MANDATORY SERVICE BULLETIN NO. MSB 40NG-063

Type: DA 40 NG

MLG Support Plate.

Figure 1 - MLG Strut Mounting

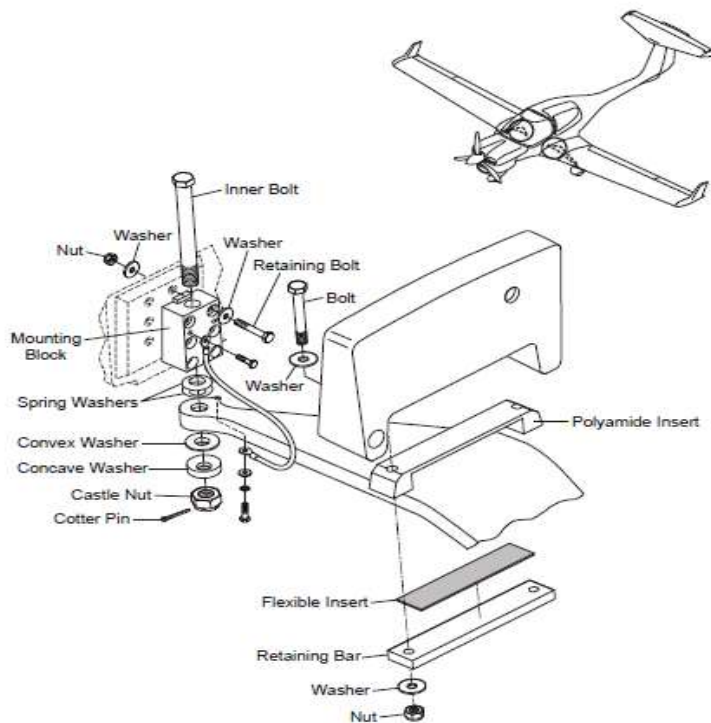
Several MLG Support Plates were found cracked. Diamond is investigating for further occurrences of this.

Step 2: Inspect the MLG Support Plate(polyamide insert) for cracks and replace as necessary. Self-Locking nuts must be replaced on reinstall.

MLG Support Plate(Polyamide Insert) - P/N D44-3213-01-52X02 Qty 2.

Self-Locking Nut - LN 9348-12 Qty 4 (**must be replaced on reinstall**)
